Board Agenda Item #:	IV A – Action Item
Date:	February 13, 2020
To:	Magnolia Educational & Research Foundation dba Magnolia Public Schools (“ <b>MPS</b> ”) Board of Directors (the “ <b>Board</b> ”)
From:	Alfredo Rubalcava, CEO & Superintendent
Staff Lead:	Patrick Ontiveros, General Counsel & Director of Facilities
RE:	Recommendation of Ad Hoc Committee to Board to Approve MSA-1 Change Order Requests

The Ad Hoc Committee recommends and moves that the MPS Board approve change order requests 37 to 54 up to \$176,614.96 as presented by Oltmans Construction Co. (“**Oltmans**”) for the new construction project for the benefit of MSA-1 at 18220 Sherman Way (the “**Project**”) with the payment amount to be confirmed by MPS Staff based on a review of all change order requests and back-up.

Oltmans Change Order Requests

# NOT APPROVED - CORRECTION NOTICE

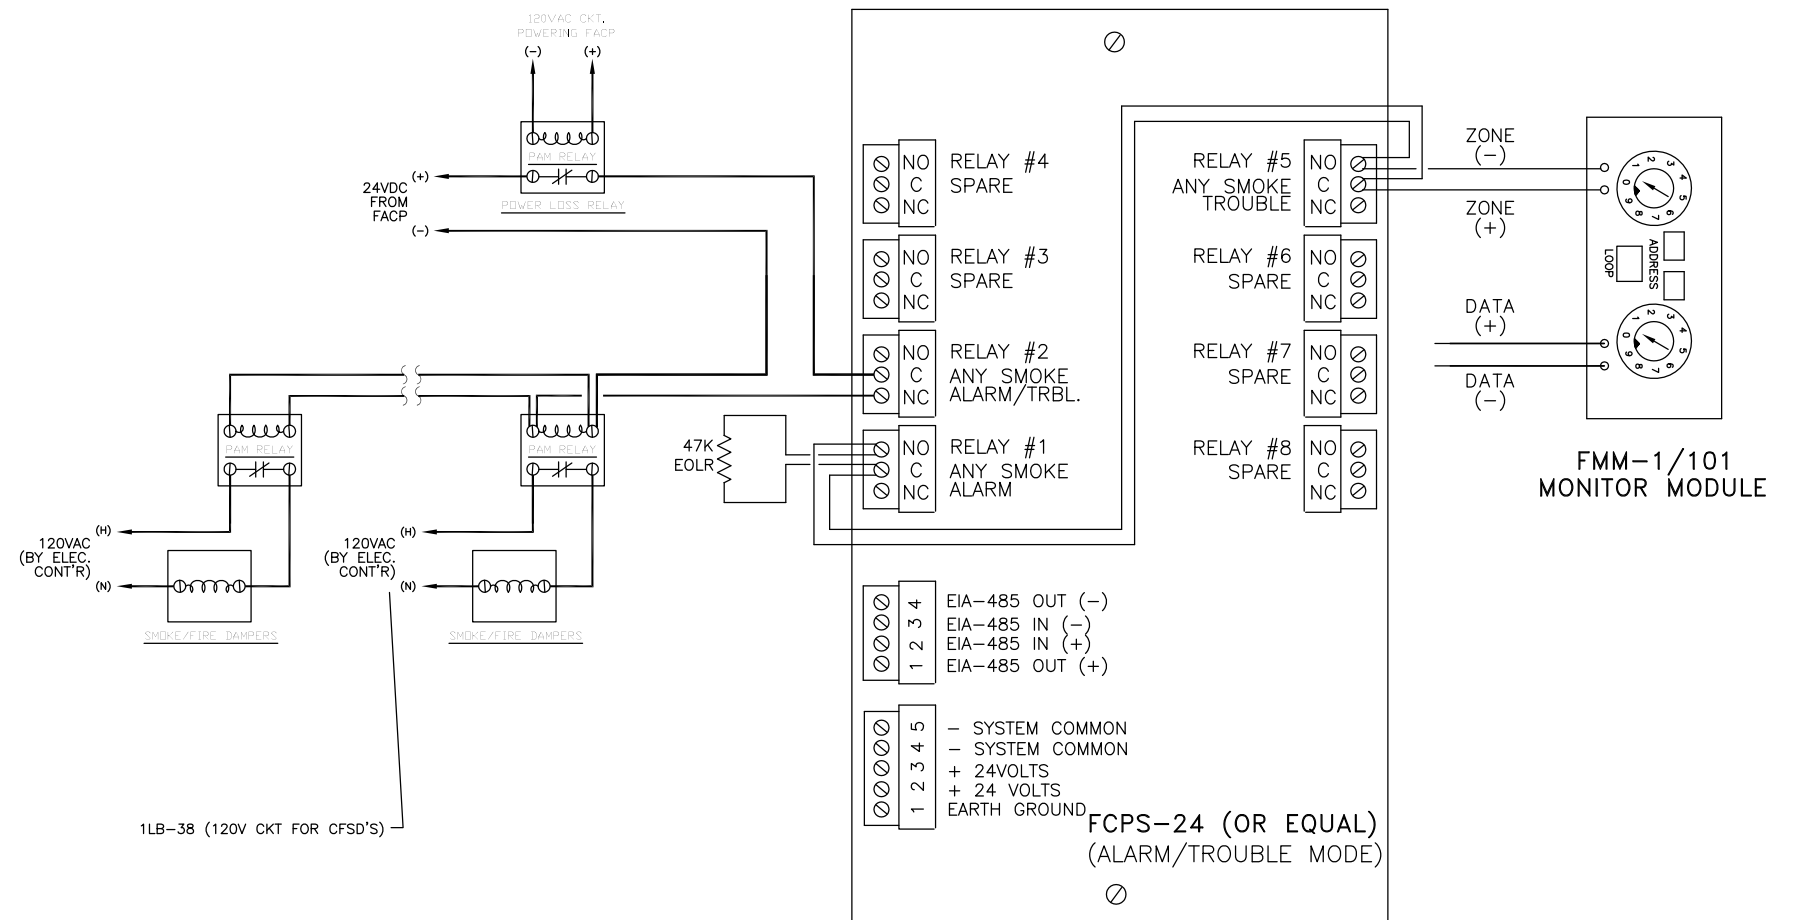
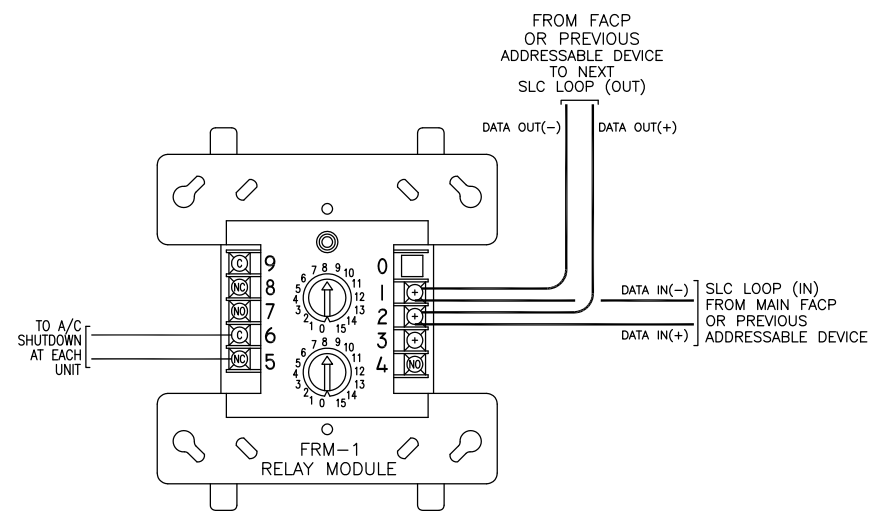
<p><b>VIOLATION NUMBER: 19-DMN-141-G-3410</b> <span style="float: right;">Date Issued: 8/14/2019</span> <span style="float: right;">Issued by</span>  <b>VIOLATION TYPE: Fan Shutdown</b>  <b>VIOLATION CODE SECTION: 95.609.0 LAMC</b>  <b>CODE LANGUAGE:</b> Provide duct detector in the main supply air plenum of all air moving systems in excess of 2000 CFM combined, such systems shall shutdown simultaneously without delay.  <b>VIOLATION NOTES:</b> Second</p>

SHEET TITLE :	<b>FIRST FLOOR H.V.A.C. PLAN</b>
PROJECT :	<b>MAGNOLIA SCIENCE ACADEMY</b>
OWNER :	18220 SHERMAN WAY RESEDA, CA 91335
DATE :	03-04-19
SCALE :	AS NOTED
DRAWN BY :	--
CHECKED BY :	--
JOB NUMBER :	18-3023
SHEET NUMBER :	<b>SD-2.0</b>

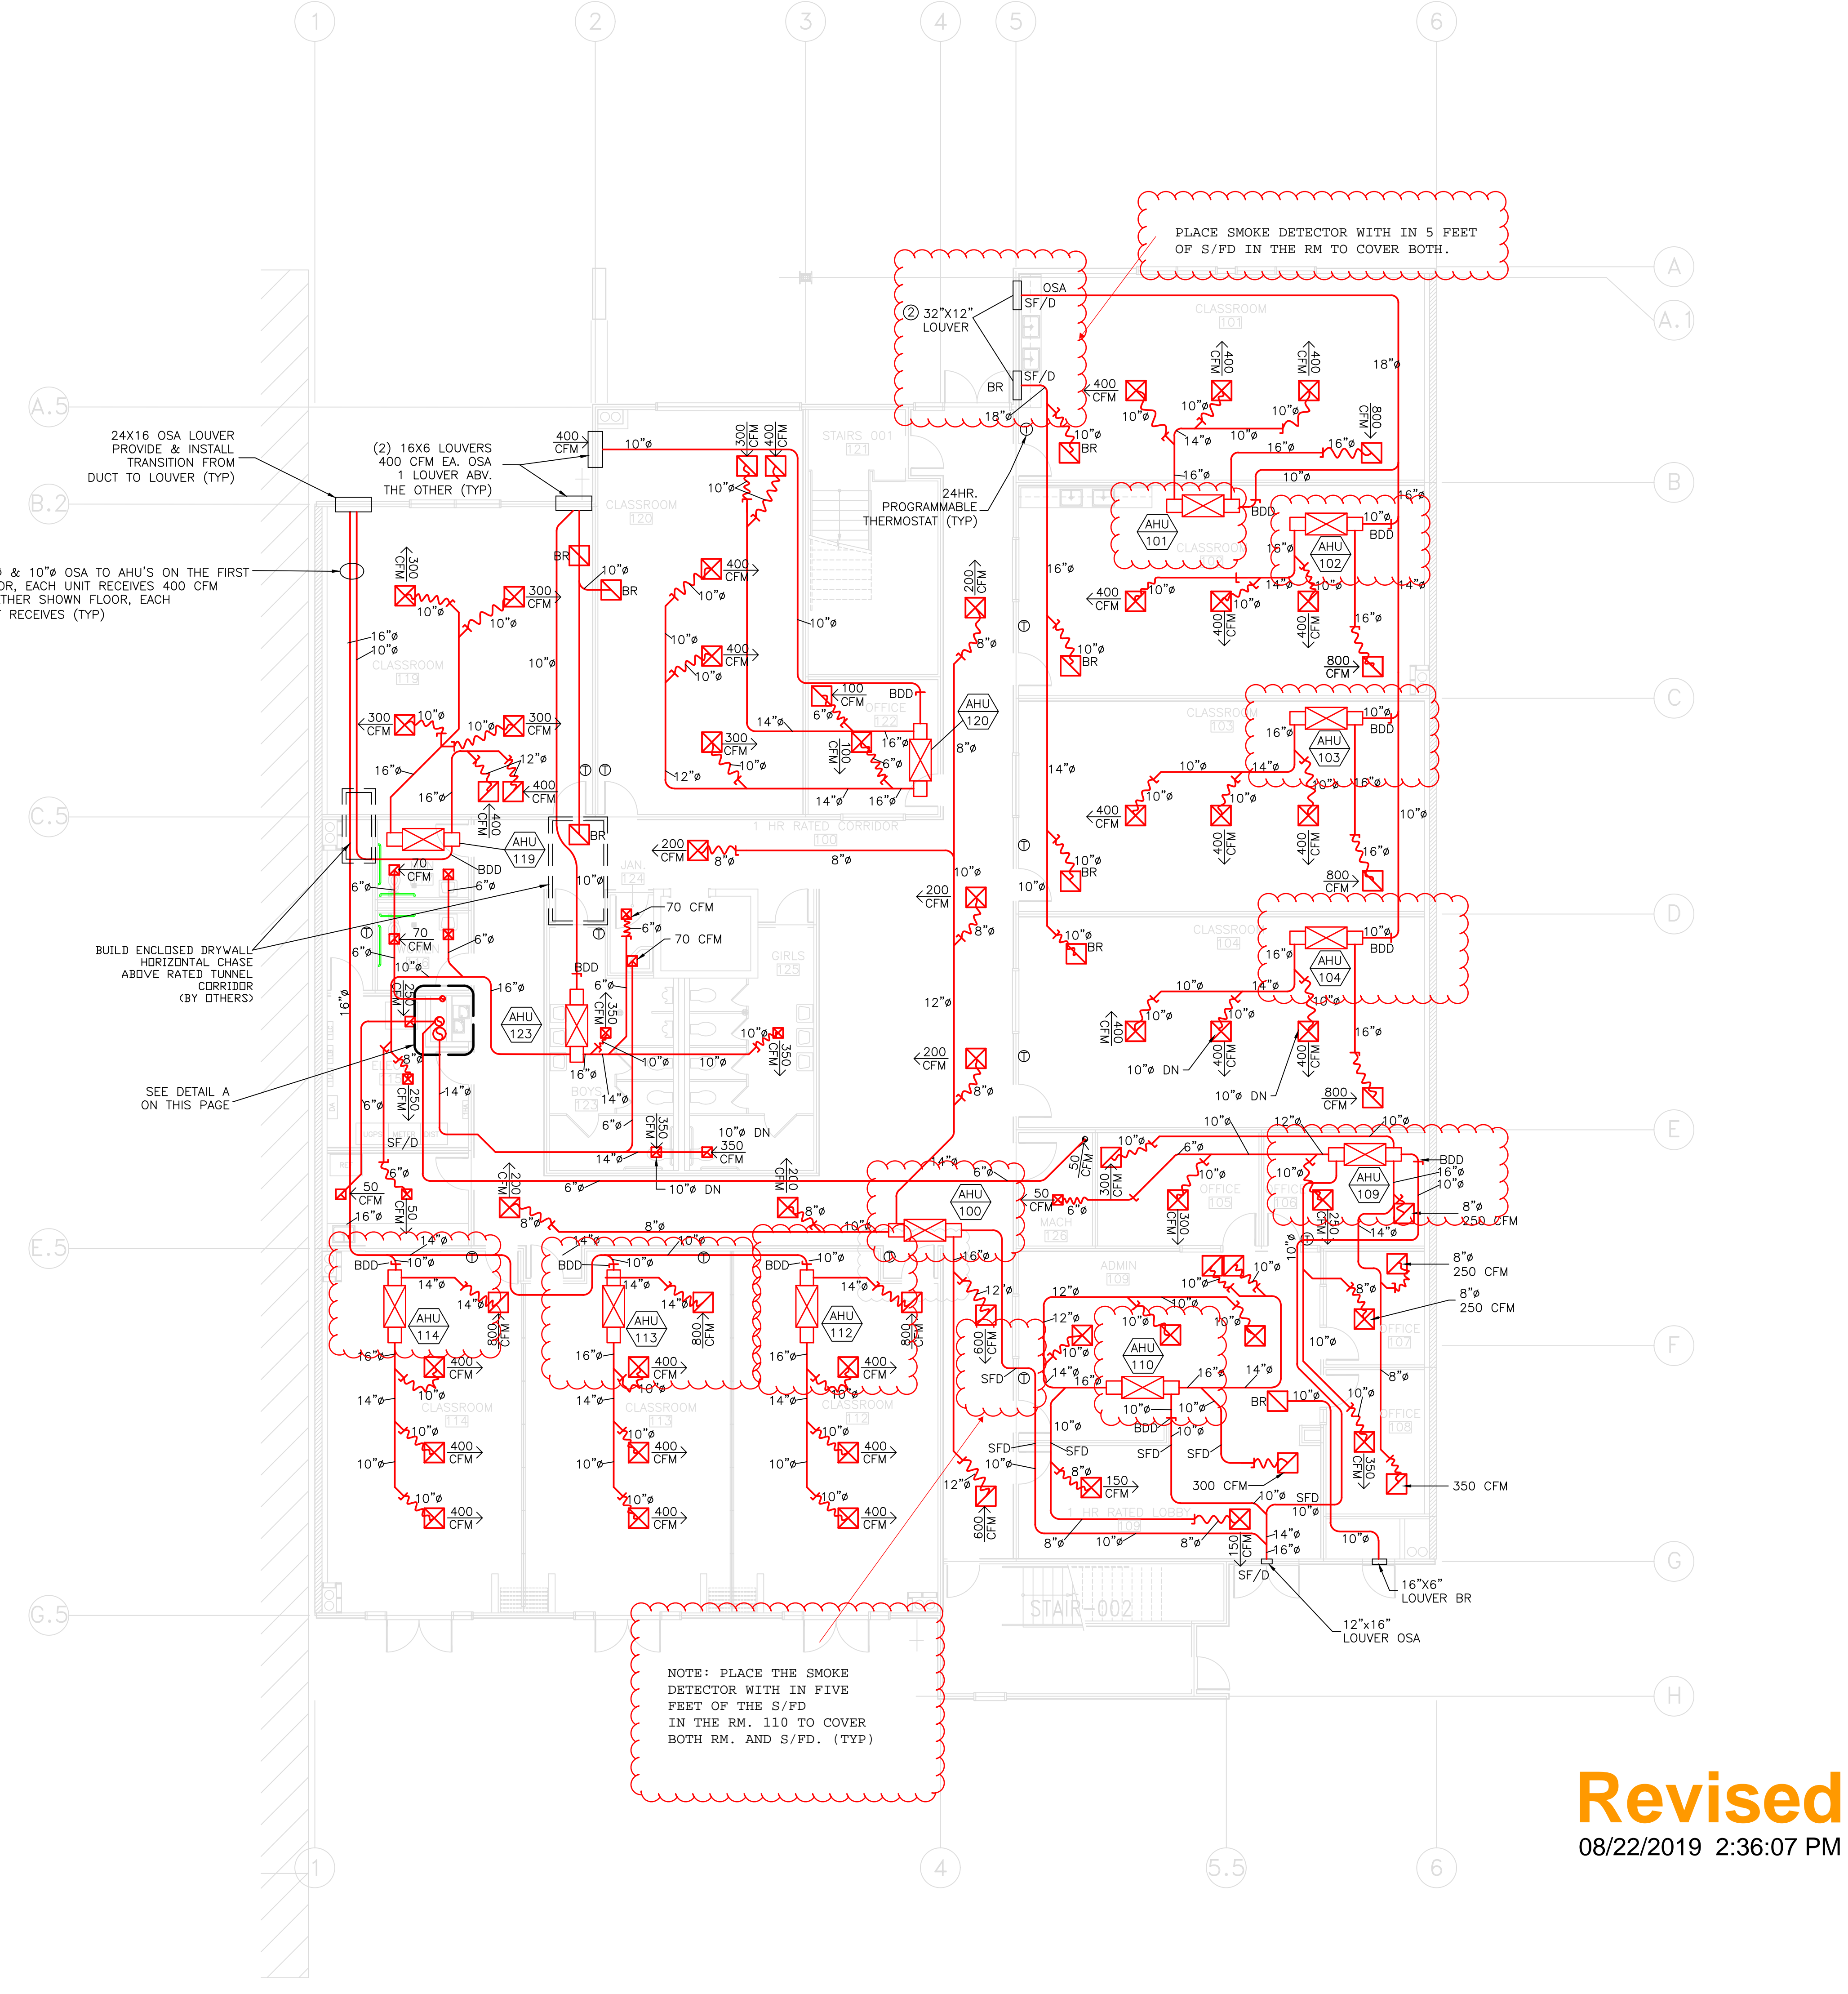
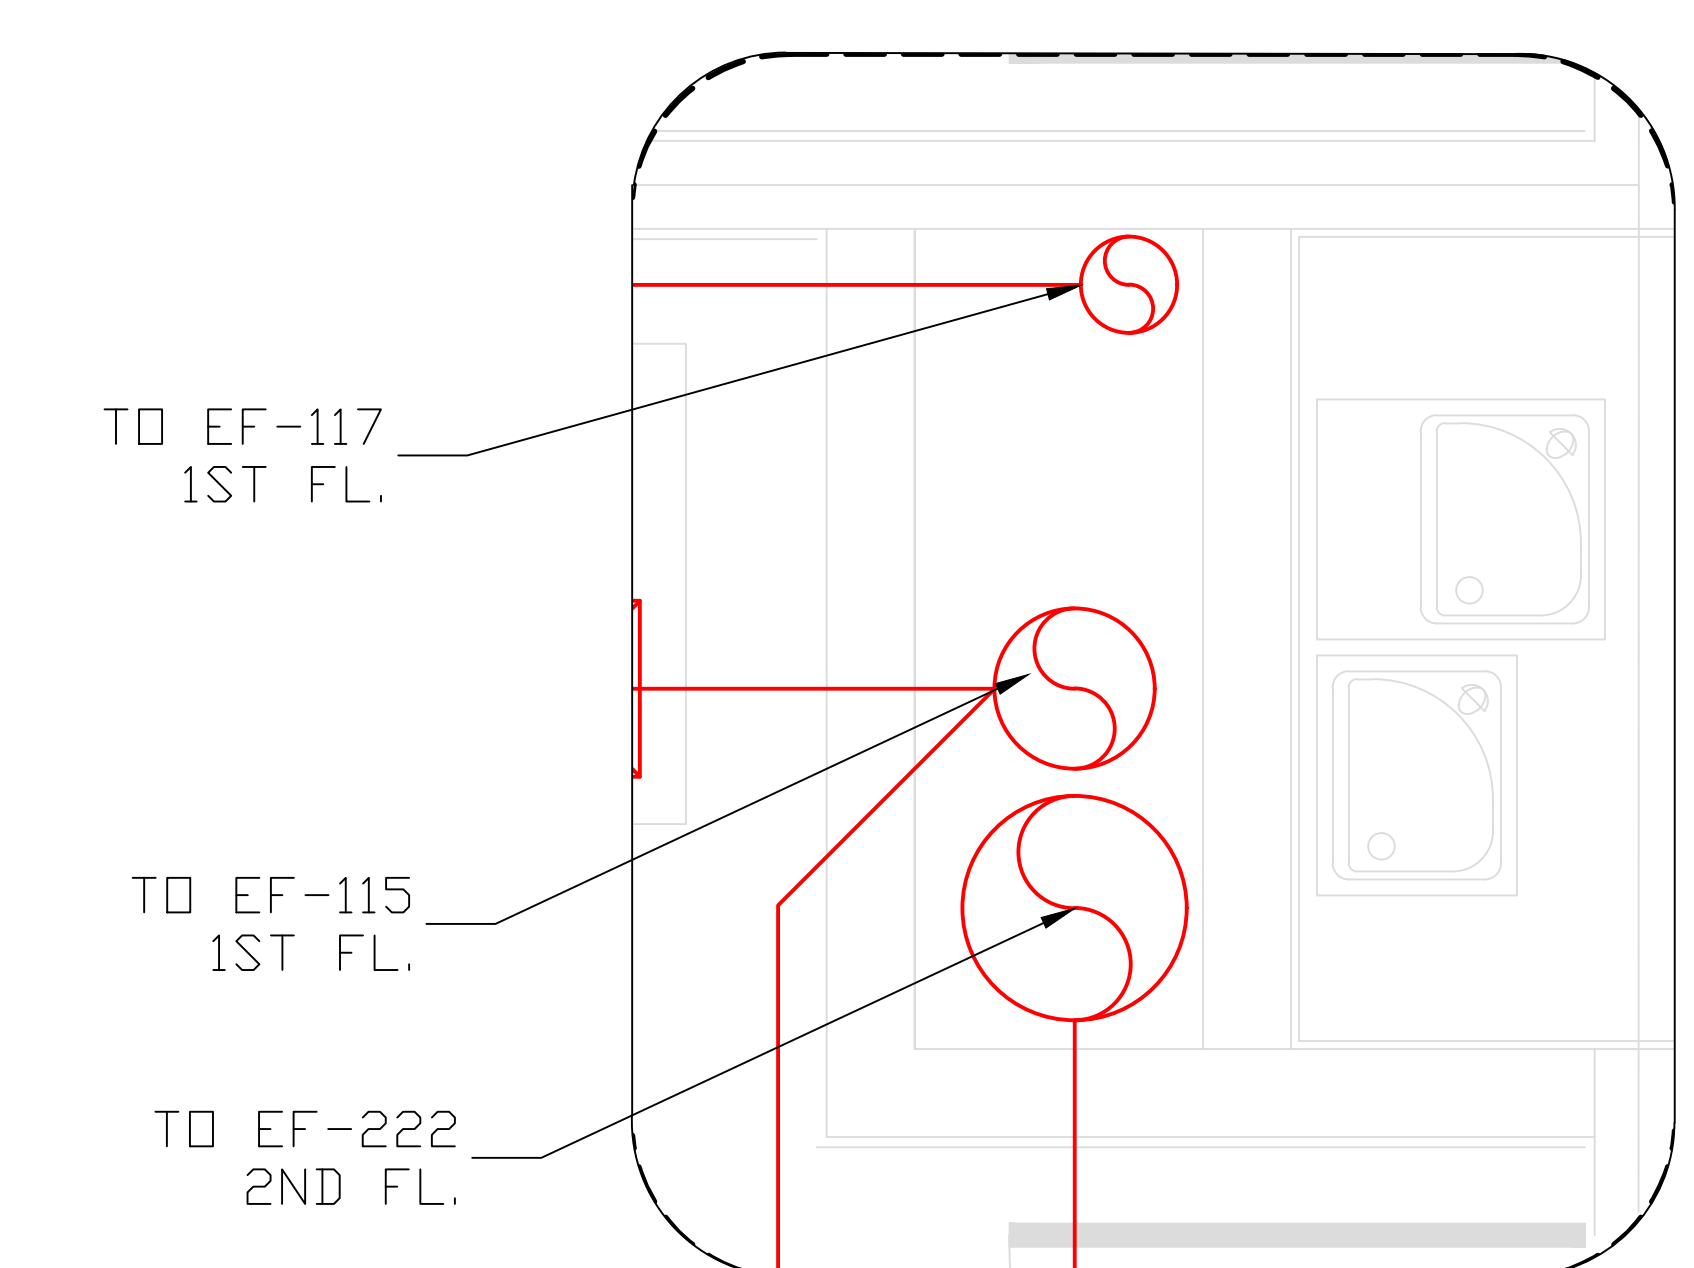
1. From shop drawing SD-2.0, rooms 100,101,102,103,104,110,1109,112,113,114. From shop drawing SD-3.0, 1 smoke detector is required within five feet of the smoke/fire damper shown on the plan I've attached and the s/fd clouded.
  2. Shut down all the units as indicated in 1.
  3. Duct detectors are not required.
  4. Yes, on the second floor SD-3.0, near kitchen, see clouded.
  5. Yes.
  6. Only in room 109. return air from any of the other room will reach rm. smoke  
**Answered By:** detector.
  7. Smoke detector in corridor, second near kitchen will suffice.
  - Date:** 8. Confirmed. Please verify with electrical.
-

PLACE SMOKE DETECTOR WITH IN 5 FEET OF S/PD IN THE RM TO COVER BOTH.
